# Memo

**Development Assessment**

**Subject:** Agenda item 1.3 – DA2020/1621 - 1 West Promenade Manly -

Alterations and additions to an existing commercial / retail building

Photo 1: Heritage Listed 65 Albert Street Freshwater.

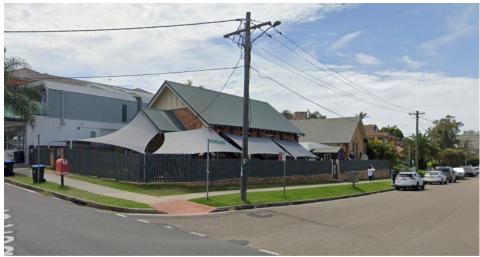
The heritage listed former uniting church building at 65 Albert Street Freshwater has had a similar style of sail awnings erected around the building. As demonstrated in the photo below, the sail awnings remove the legibility of important features such as the windows, brick banding, piers and the projecting front gable entrance to the church.

As such, the visual impact of the five (5) sails awnings are not considered to be minor, nor consistent with DCP controls and do not retain or conserve the cultural significance of Manly.
